Page 2
RailPAC Comments
High Speed Rail Burbank – Los Angeles EIR-EIS

Response to Submission 764 (Paul Dyson, Rail Passenger Association of California and Nevada (RailPAC), July 30, 2020)

Response to Submission 692 (Steve Riboli, San Antonio Winery, Inc, June 23, 2020)

FIGURE 1

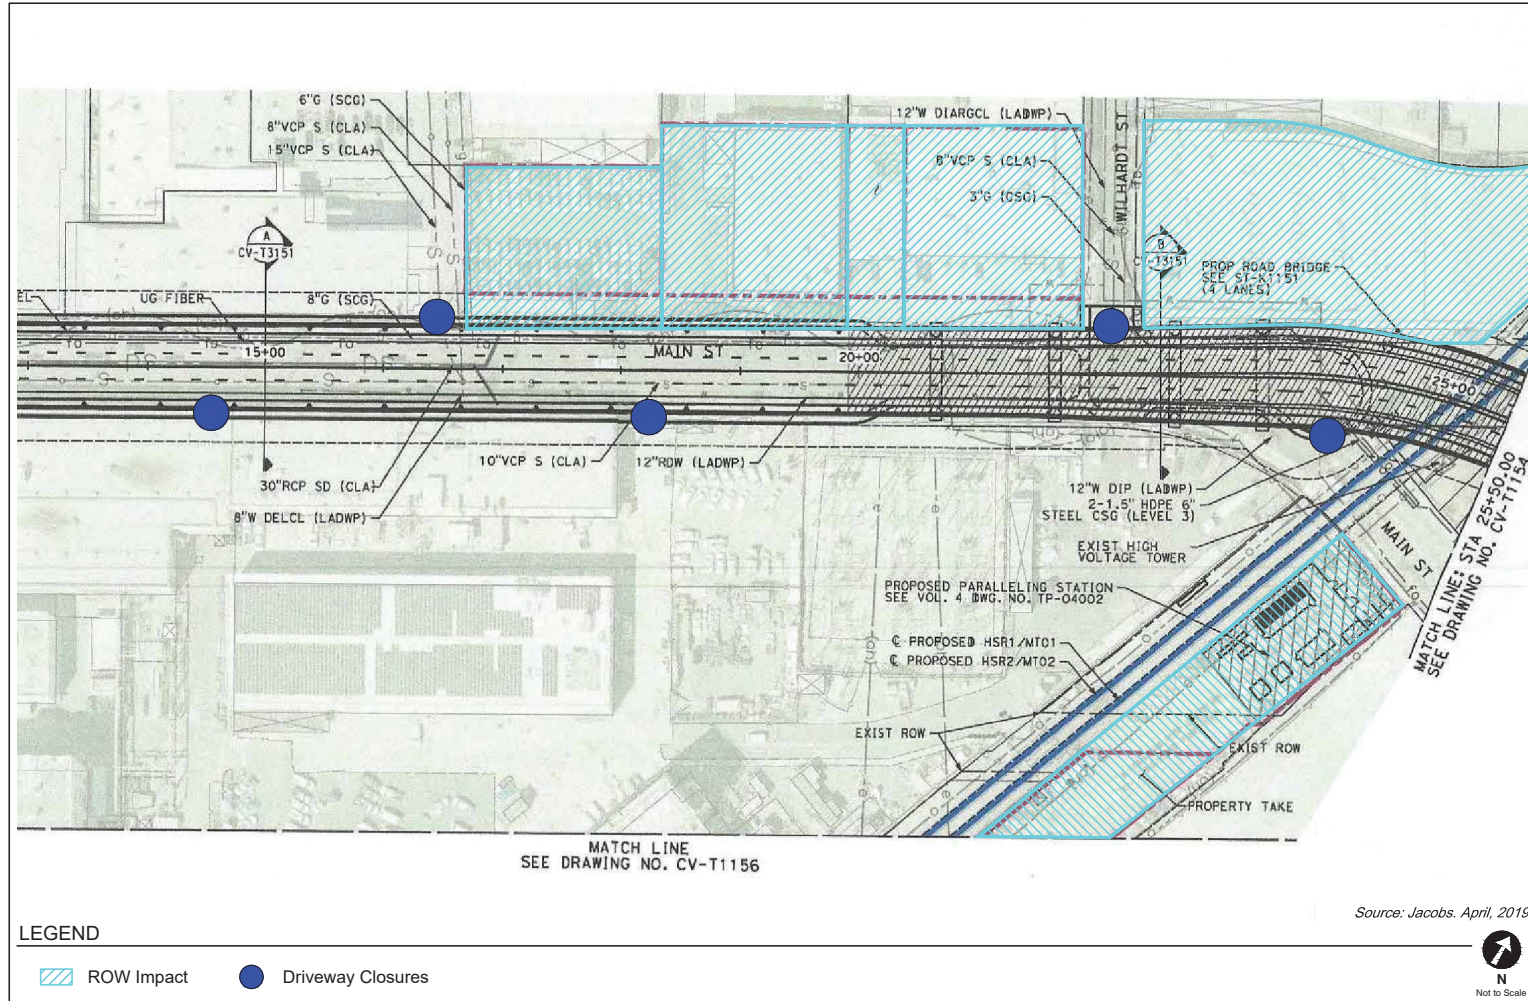
If the projected train activity levels actually materialize and the grade separation is needed, we have some operational concerns with the current conceptual design, shown in Figure 1. For the purposes of our analysis, GTC divided the area into four quadrants separated by the L.A. River and Main Street.

The draft concept¹, illustrated in Figure 1, shows two large triangular-shaped areas consisting of multiple parcels and deemed as having "potential effects" from the HSR Project. Most of the businesses in these two triangles appear to take their primary access from Main Street and, therefore, it is very likely that these parcels will need to be completely acquired and demolished rather than "potentially effected".

The commenter expressed some operational concerns with the current conceptual design of the Main Street Grade Separation. The design for the Main Street Grade Separation has been refined and the Authority has and will continue to work with the City of Los Angeles and local stakeholders regarding this design. Section 2.5.2.9 shows a revised overview figure of the design, while the drawings can be found in Volume 3 of this Final EIR/EIS, specifically in Volume 3: Grade Separations. The street network has been revised to address stakeholder concerns regarding circulation, including providing a direct connection between Lamar Street and the new Main Street, removing a connection between Lamar Street and Clover Street, and maintaining the existing Clover/Main intersection conditions.

The comment states that most of the businesses shown on Figure 1 in the KOA memorandum would need to be acquired rather than potentially affected. In response to public comments on the Draft EIR/EIS, design changes were made to the Main Street Grade Separation to further reduce impacts to the community to the extent feasible. Revisions have been made to Volume III and Appendix 3.12-D, Property Acquisitions and Easements, of this Final EIR/EIS.

FIGURE
2A

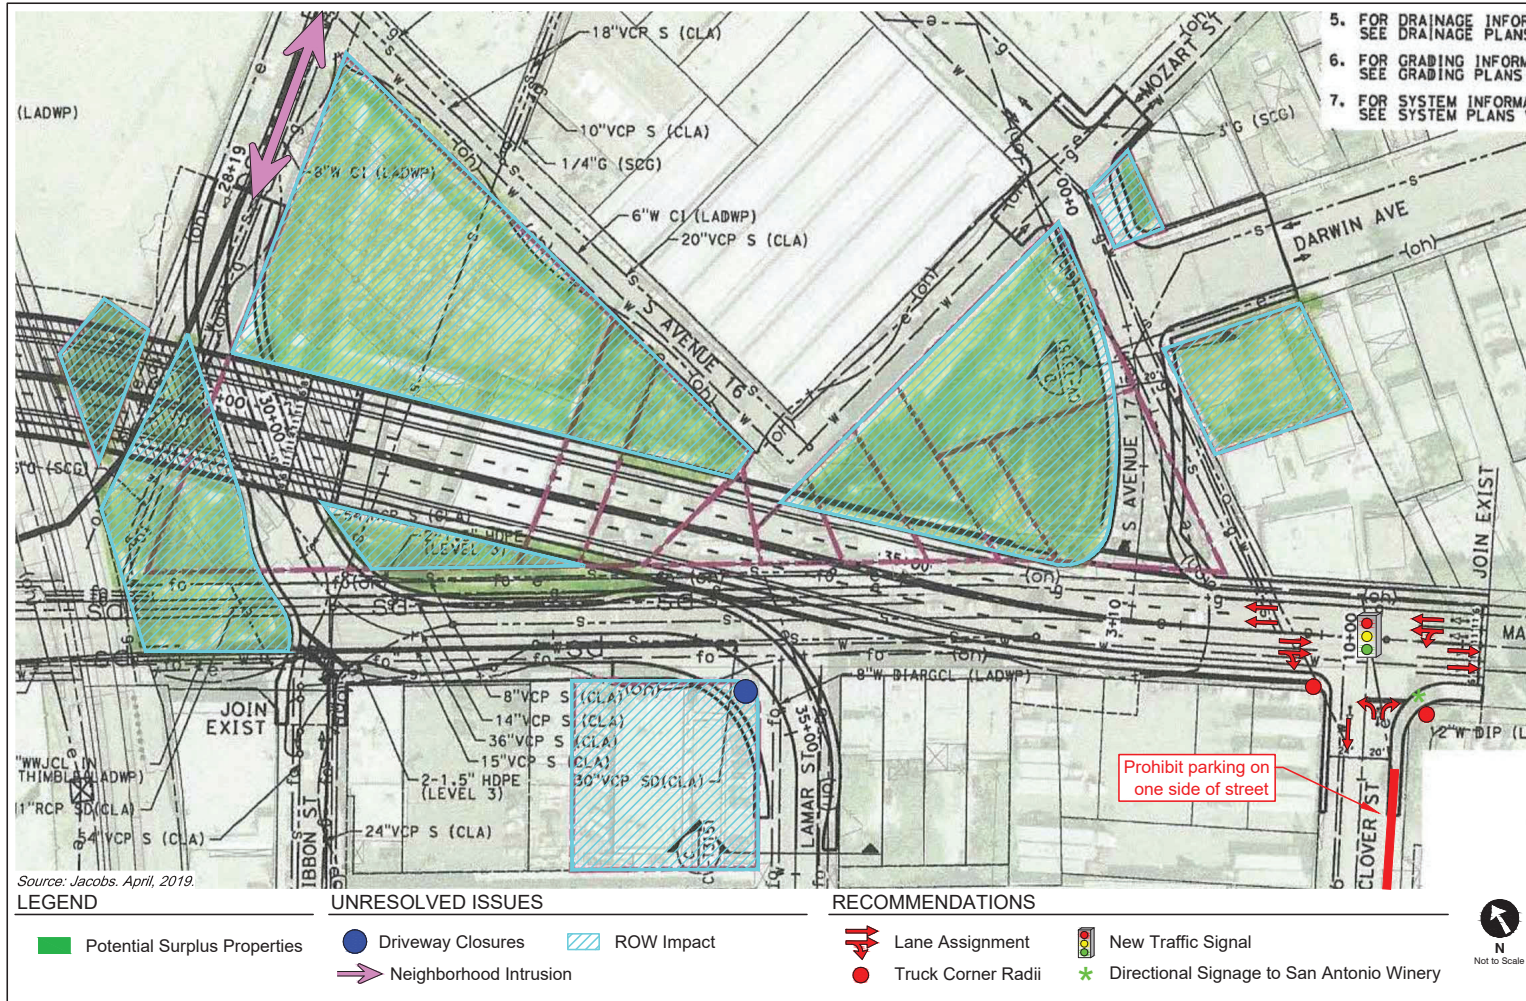
These land uses generate a substantial number of trucks per day and, thus, special considerations will need to be included in the design for the eastern end of the overpass. We recommend the following improvements, illustrated in Figures 2A-2C, be added as mitigation measures to the Main Street Overpass proposal:

The commenter expresses concern regarding the design of the Main Street overpass and provides recommendations for mitigation measures. The commenter requests large turning radii on the corners of Clover Street and Main Street and the new east-west street. Refer to BLA-Response-Section 3.12 SOCIO-03: Impacts Related to the Main Street Grade Separation for information about the Main Street Grade Separation and the design refinements made at this location in response to public comments. Specific responses to this comment are provided below.
